**Re:** Request to amend certificate of authorization to include additional lands on the right bank  
Innavik Hydroelectric Project, Inukjuak  
N/Ref: 3215-10-005

**Re: Excavation of hydroelectric station site, tailrace and headrace of the Innavik Hydroelectric Project – Rerouting of tailrace, relocation of sedimentation ponds and addition of a work and storage area**

Re: Amendment to authorization for the construction of an access road as well as storage and work areas  
– Innavik Project

INNAVIK HYDROELECTRIC PROJECT	
INTAKE AND TAILRACE WATERWAY	
FILE No.	PROJECT No.
INK-tailrace-2e-3(W10.25+EL18).dwg	81.XX
DRAWING No.	FIGURE 3.0
	D

**Carte 1** Plan de localisation des modifications

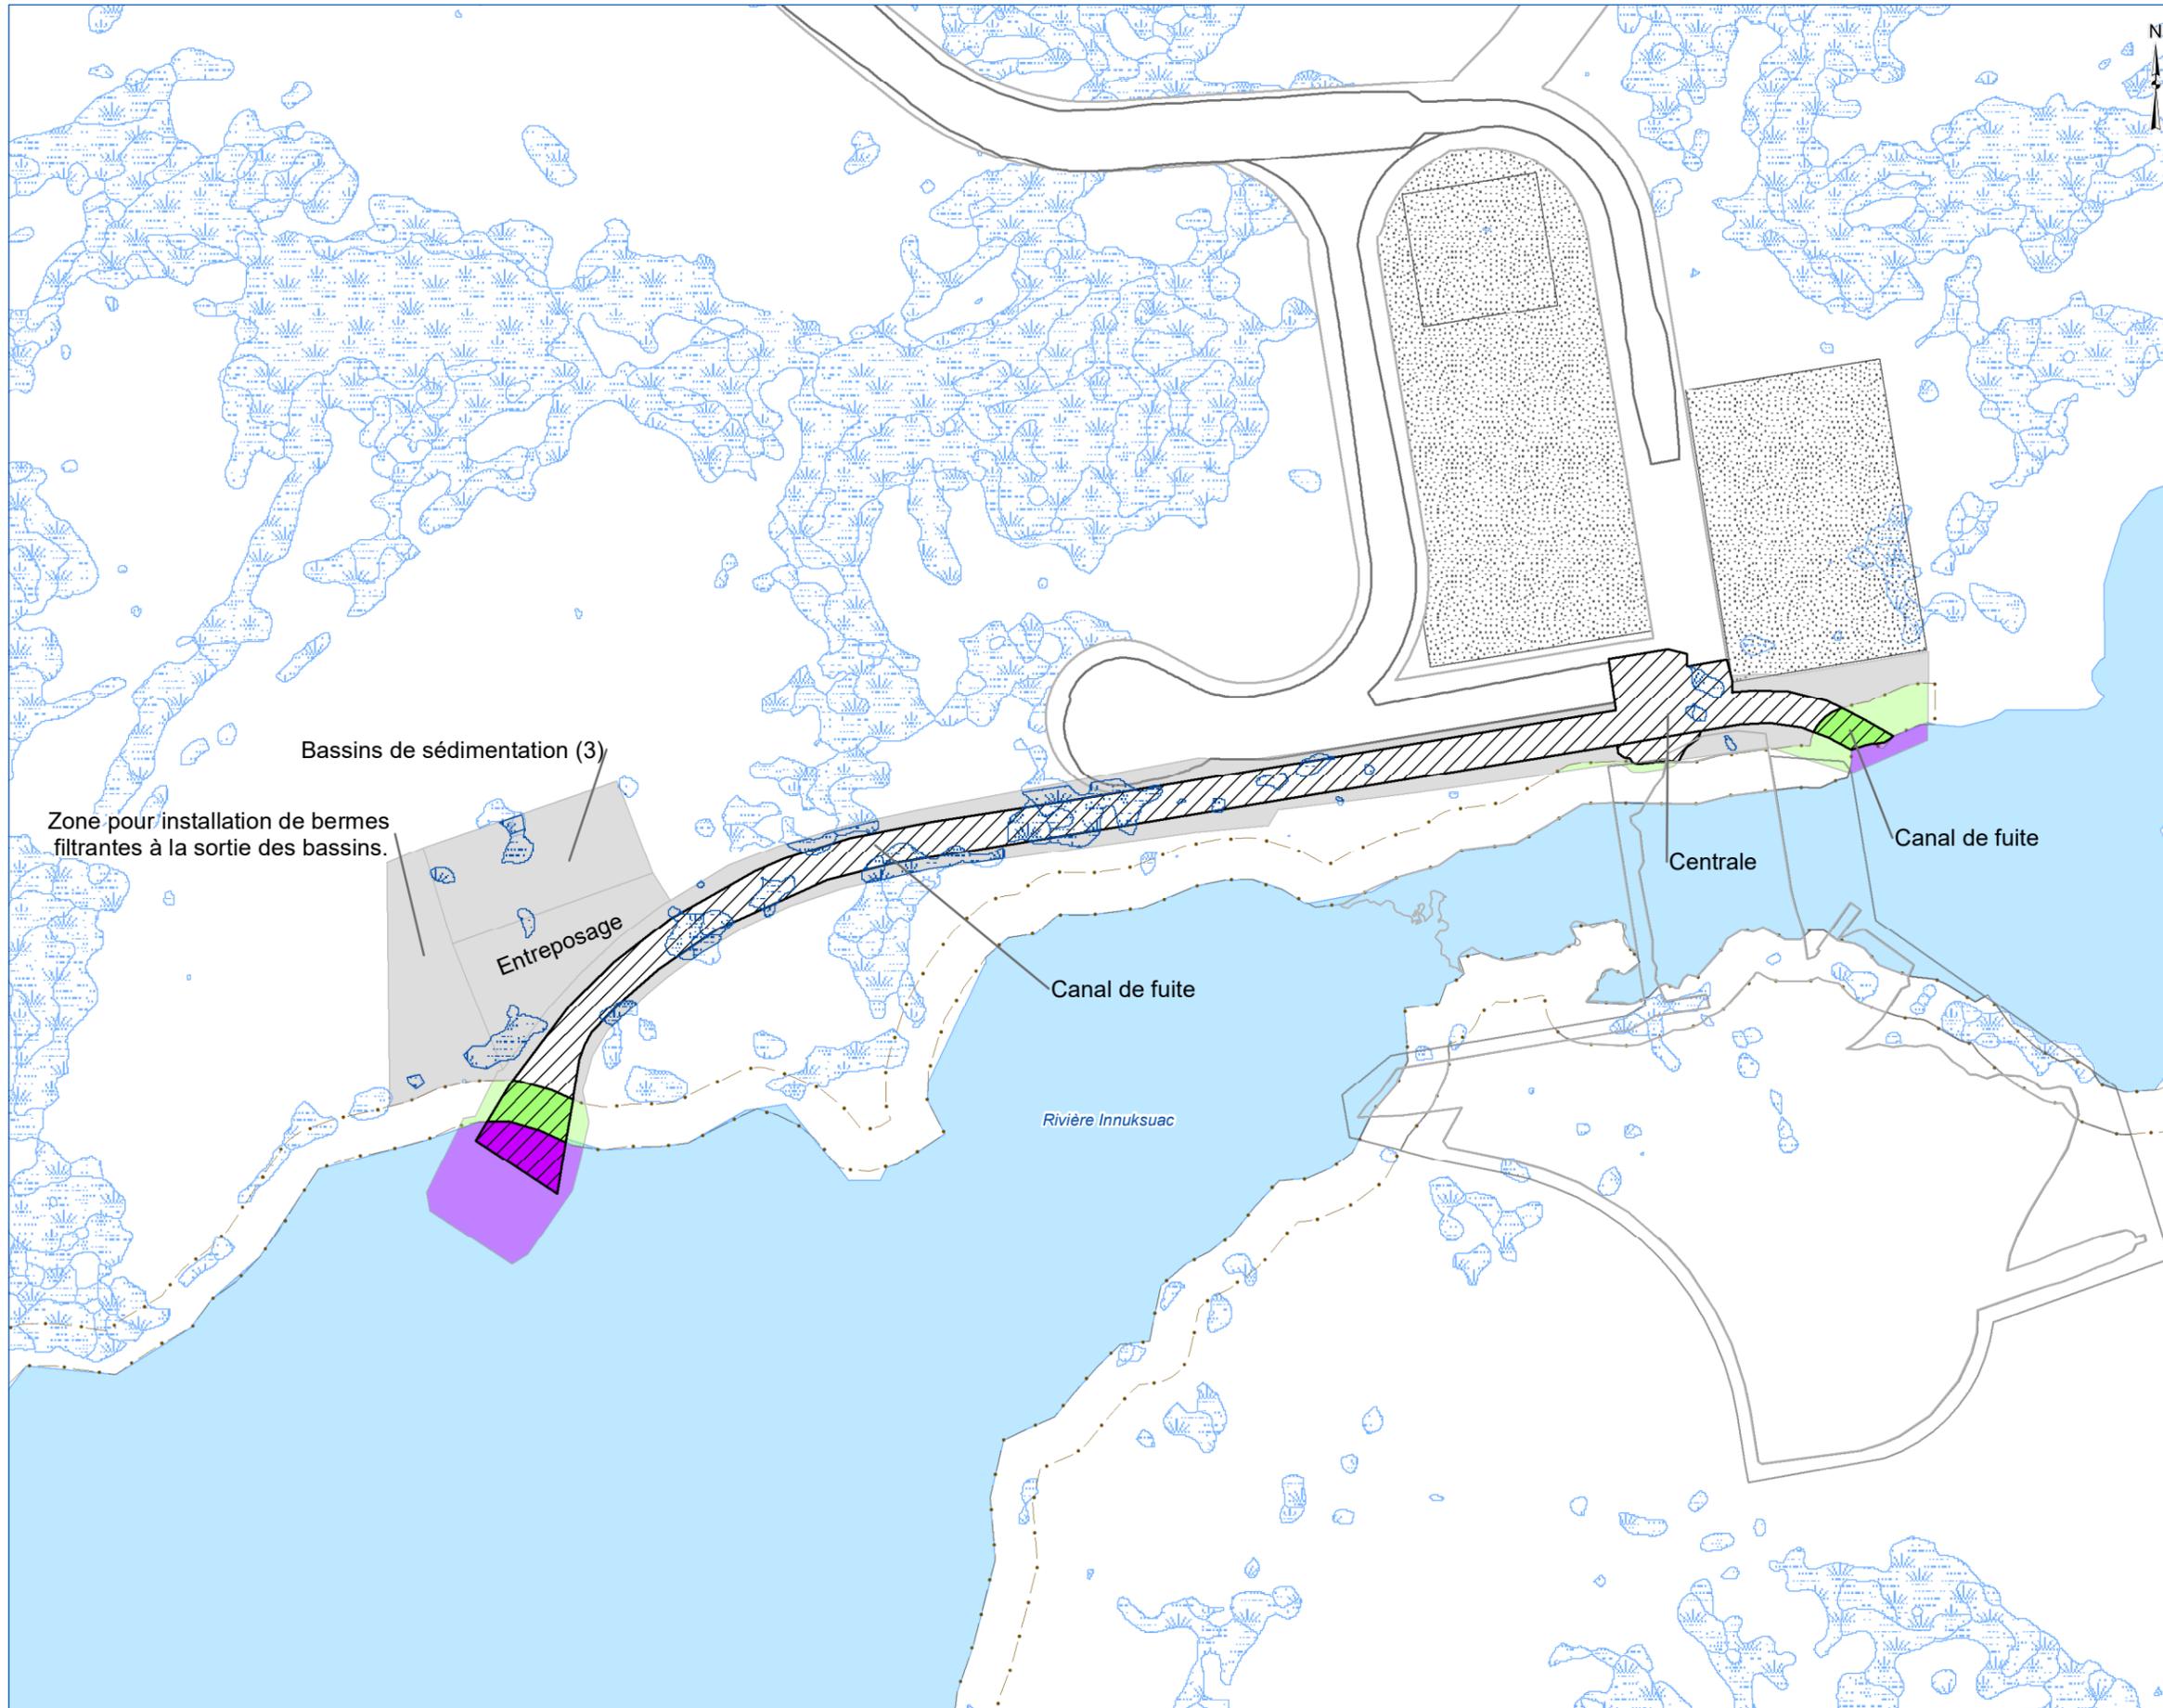
The first modification consists of enlarging and slightly relocating the backfill storage area on the right bank. This area was indicated as measuring 18,081.9 m<sup>2</sup> in the authorization application. It needs to be enlarged to 24,679.3 m<sup>2</sup> in order to allow for the safe storage of dynamited rock from the excavation of the dam site. The entire storage area will be maintained following completion of the work phase for the permanent storage of dynamited rock.

The storage area must also be slightly relocated to respect the natural topology of the land (see Location Map in the Appendix). All mitigation measures presented in the application will be maintained, namely the installation of a geotextile membrane for erosion and sediment management and the creation of sediment traps. Catchment basins will be created to capture runoff at low points.

The second modification consists of enlarging the access area. An area measuring 6,046 m<sup>2</sup> will have to be added to the existing access area (7,460 m<sup>2</sup>) for a total surface area of 13,506 m<sup>2</sup>. This enlargement is necessary due to a lack of space at the work site and in order to allow for the safe circulation of vehicles on

**Carte 1** Excavation en rive nord - Modification des emprises de travaux en milieux humide et hydrique

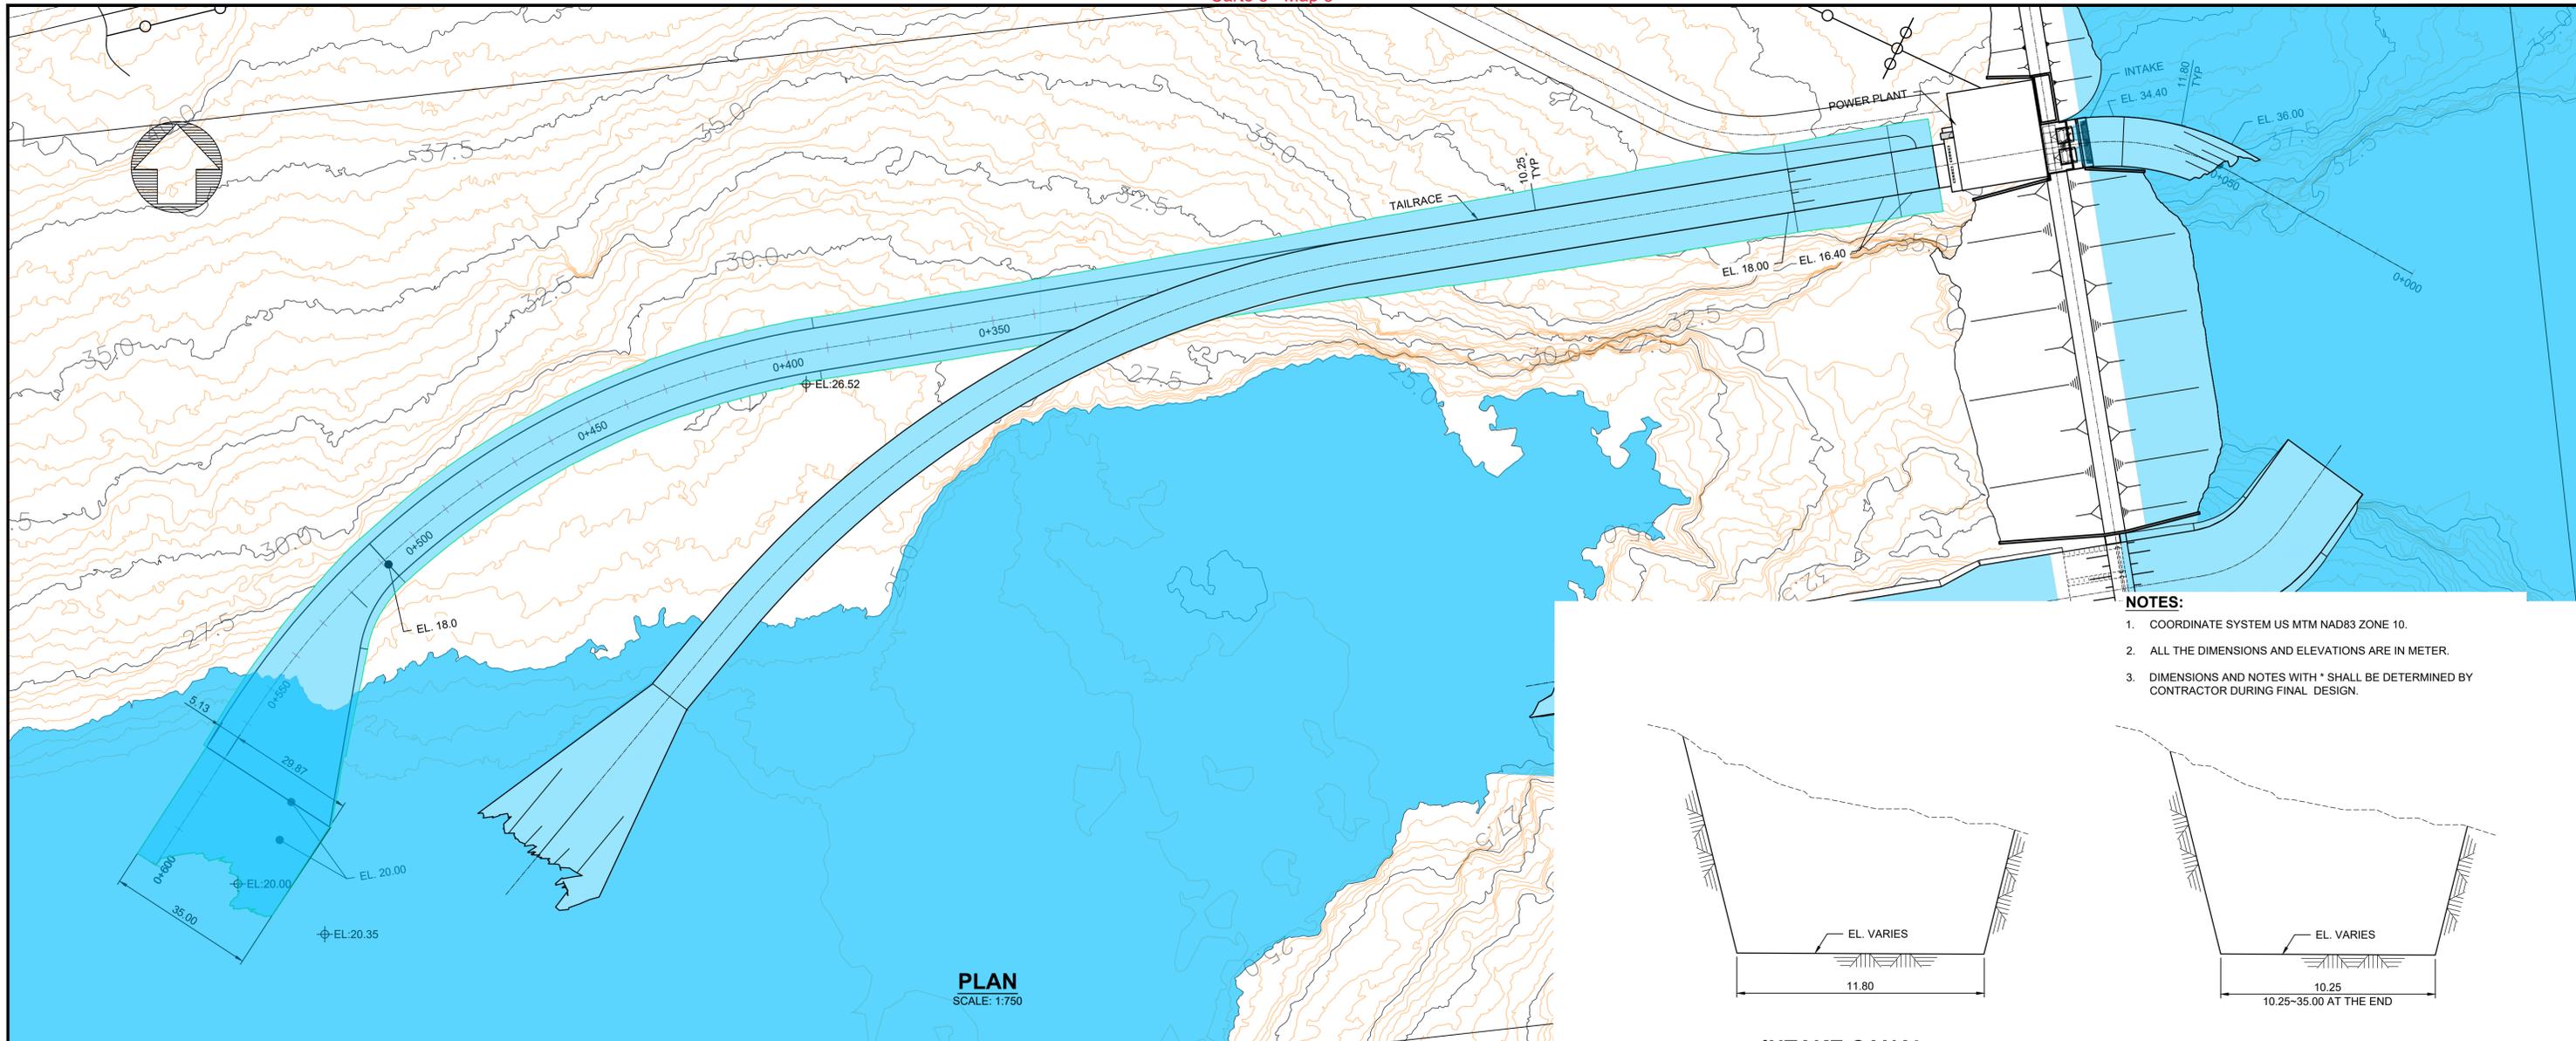
The tailrace will be rerouted so that its outlet is farther downstream; it is therefore correspondingly longer. The modification is presented in the enclosed plan and in Map 1. The surface area of the rerouted tailrace is increased to 6,083.8 m<sup>2</sup>.

The sedimentation ponds that were initially to be created in the tailrace right-of-way will be relocated to the side of the said right-of-way. In fact, the volume of water from excavations is less than initially planned, hence the need to site the ponds outside the tailrace excavation area. Three sedimentation ponds will be constructed and will occupy an area measuring 2,670 m<sup>2</sup>. Moreover, filter berms occupying a surface area of 2,304 m<sup>2</sup> will be constructed to reduce flow velocity and thus any soil erosion that might be triggered by water flowing from the ponds. This surface area (see Map 1) will be used temporarily and will be restored after the work has been completed.

Between the tailrace and the pond area, a work and storage area spanning 2,091.3 m<sup>2</sup> will be created. This area will also be temporary.

With regard to encroachment on wetlands or aquatic areas, Table 1 presents an updated summary of wetland and aquatic areas that will be affected by all work covered by the authorization and the modifications that will be made to the project. These areas are also presented in Map 1 (enclosed).

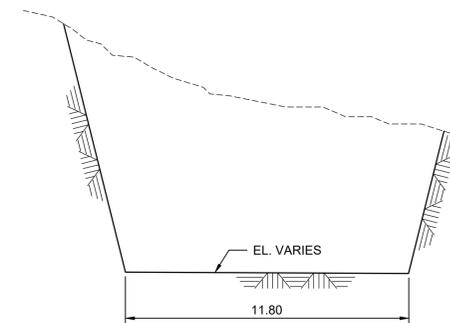
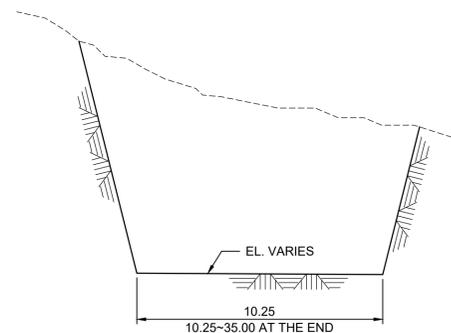
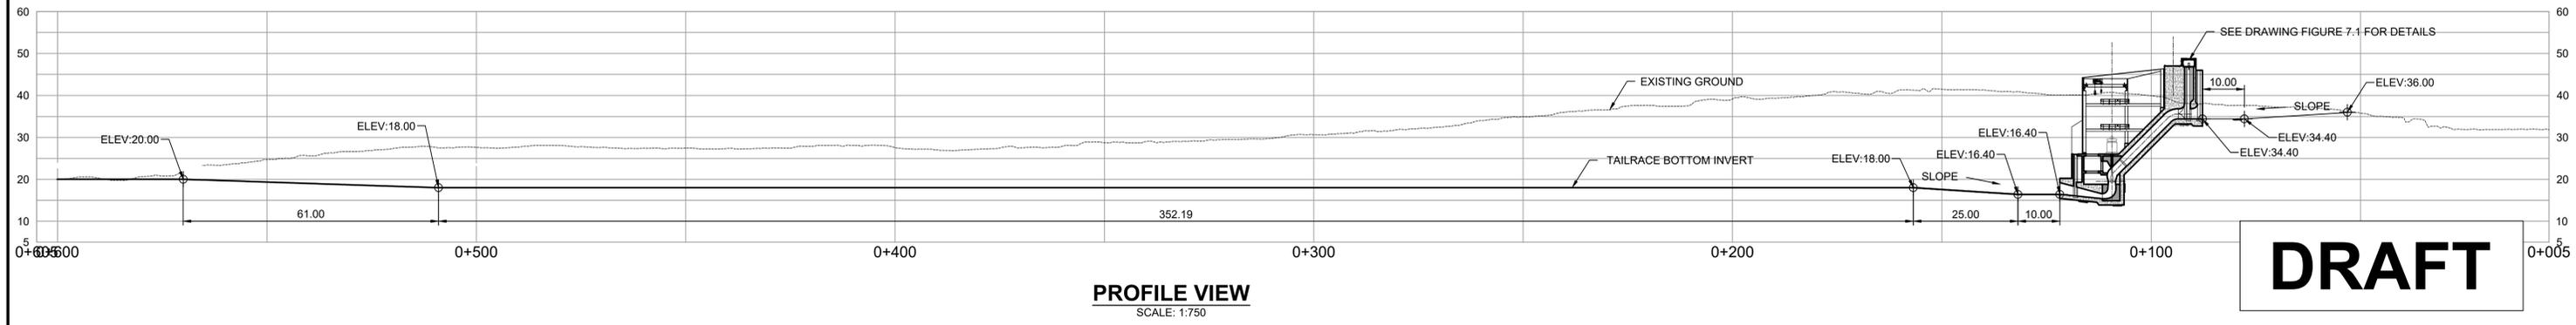
The tailrace area, covering 4,707 m<sup>2</sup>, was authorized on July 10, 2020 (N/Ref: 7430-10-01-10031-02, 401935683). The tailrace's path has been modified so that its outlet is moved further downstream because the overburden was not suitable for tailrace construction (maps 2 and 3). Therefore, the tailrace area is expanded to a total of 6,084 m<sup>2</sup>.
